United City of Yorkville

AGENDA ECONOMIC DEVELOPMENT COMMITTEE MEETING

Tuesday, June 4, 2024

7. EDC 2024-41 Cyrus One – Preliminary PUD Plan

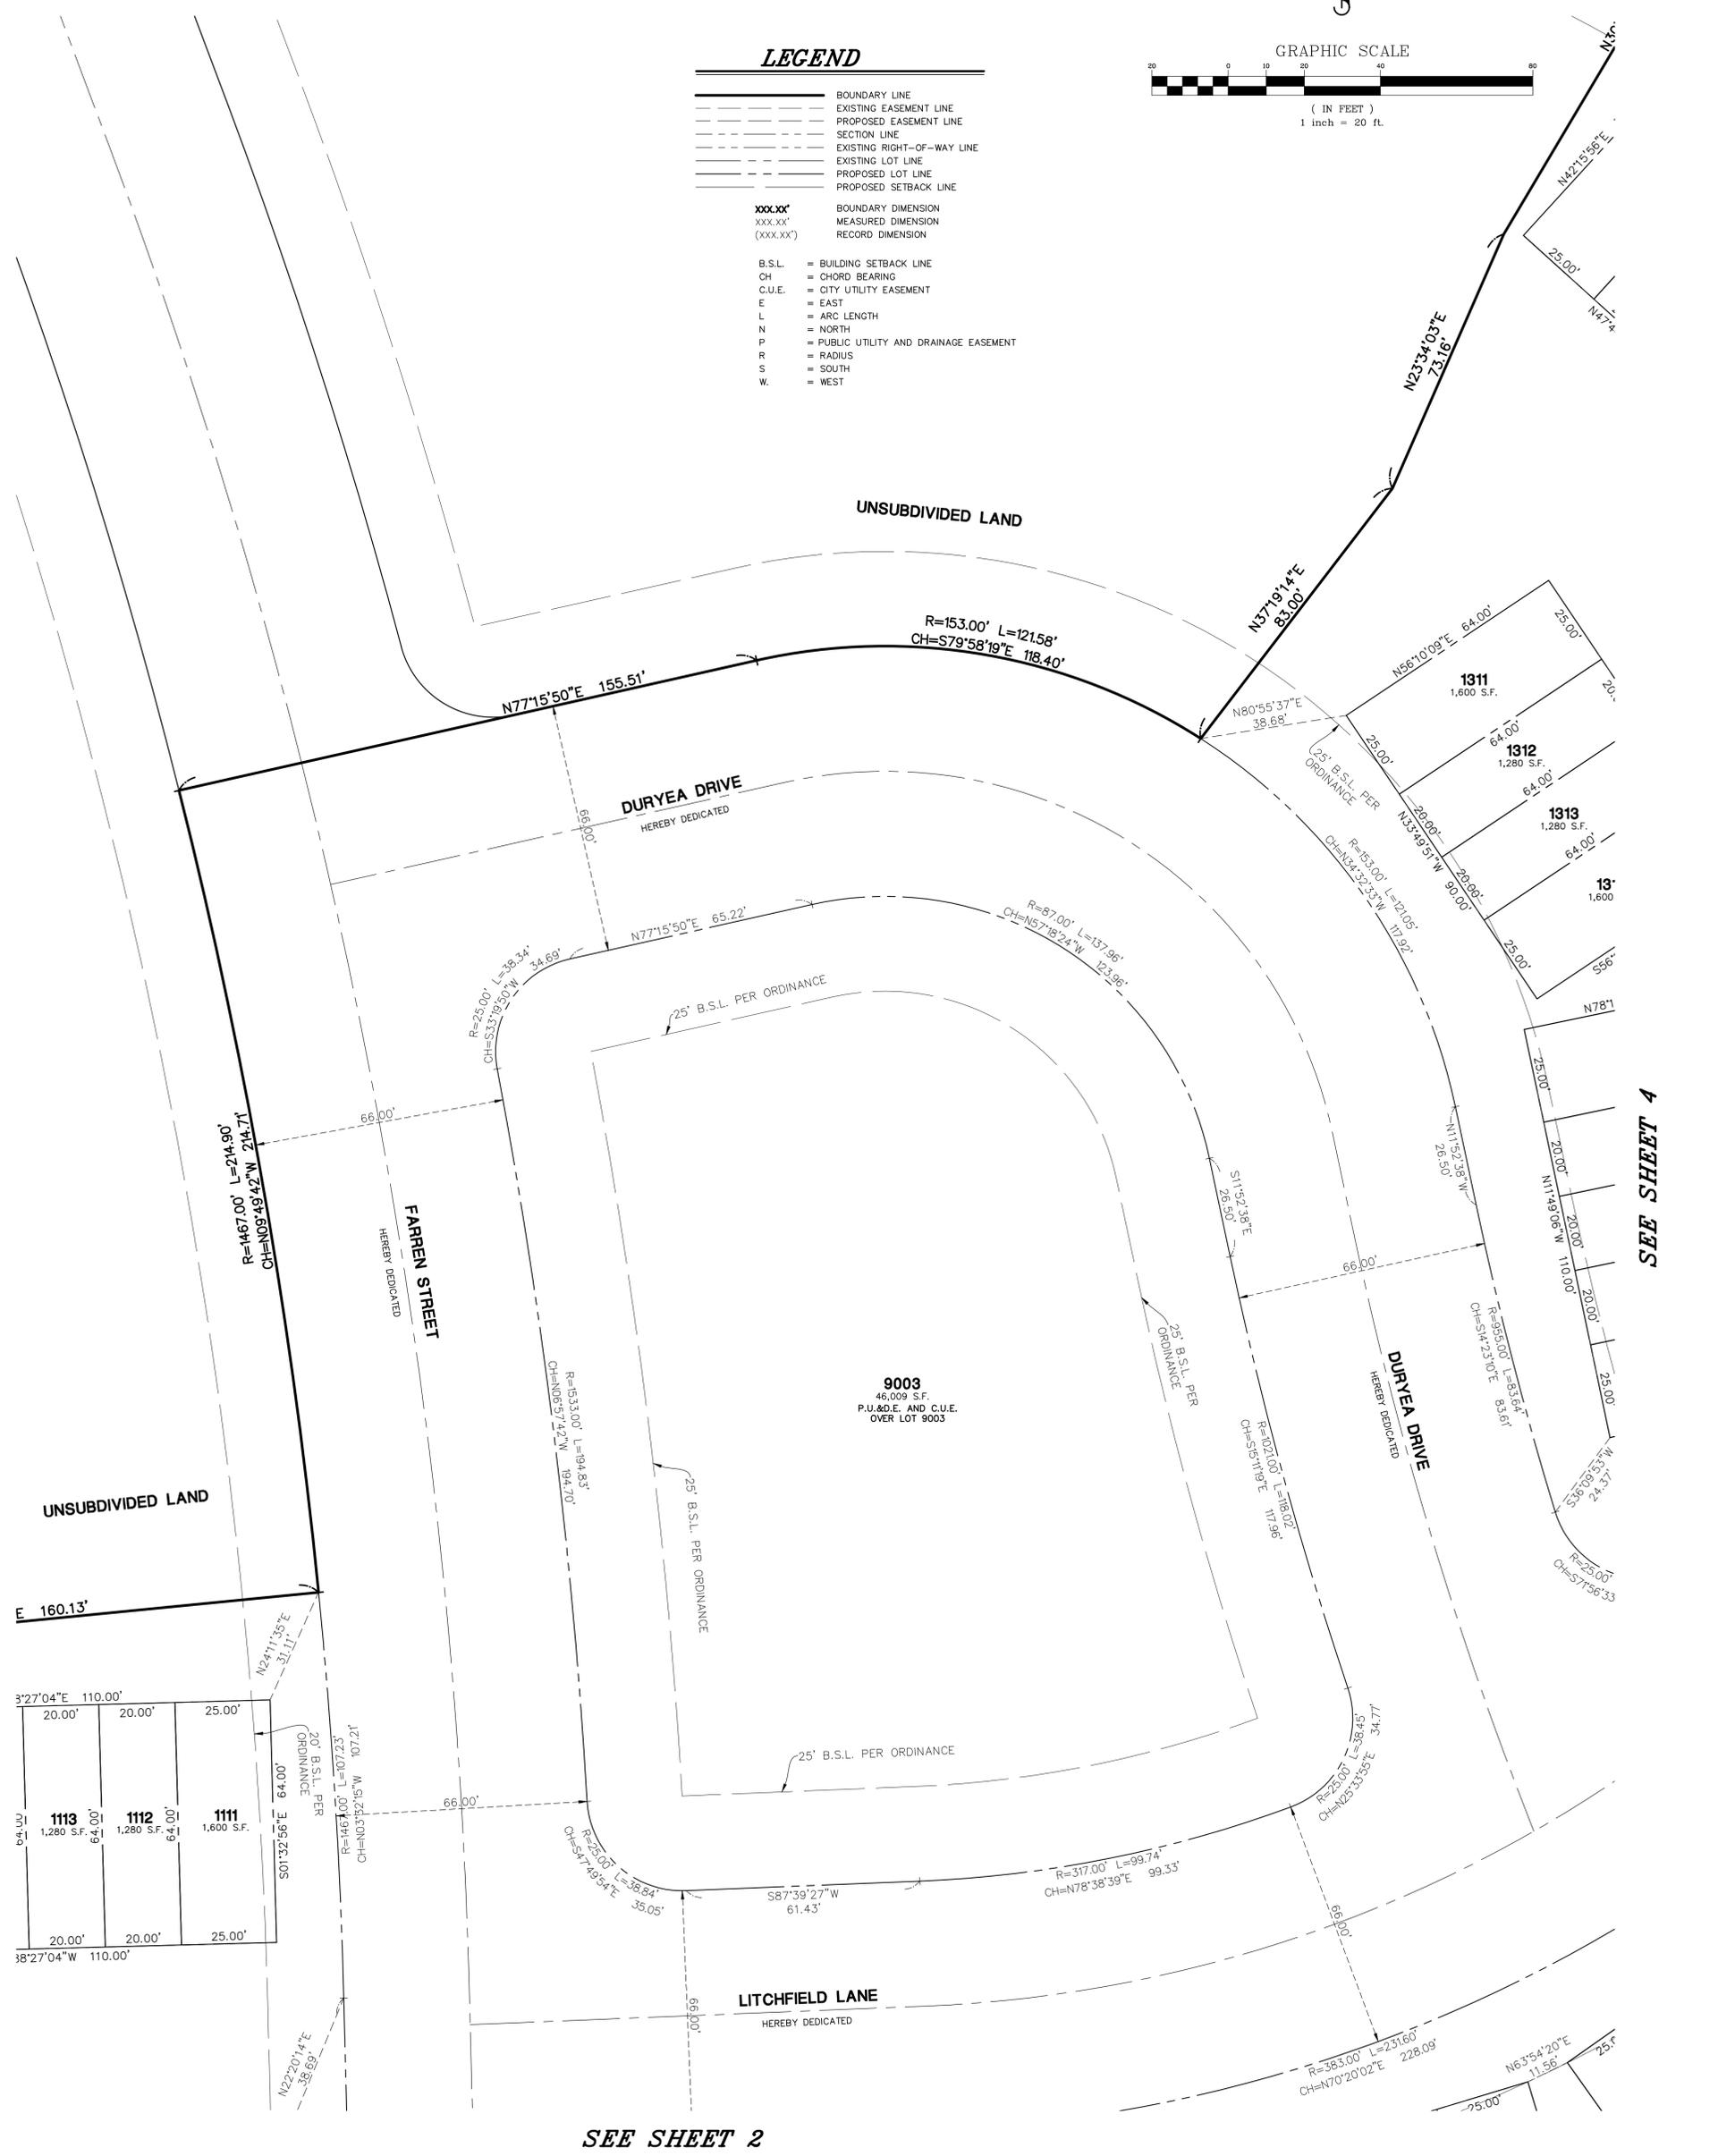
82. Add dimensions to the south line of Matlock Drive on sheet 5.

86. Label or remove the lines running down the center of sheets 5 and 6.
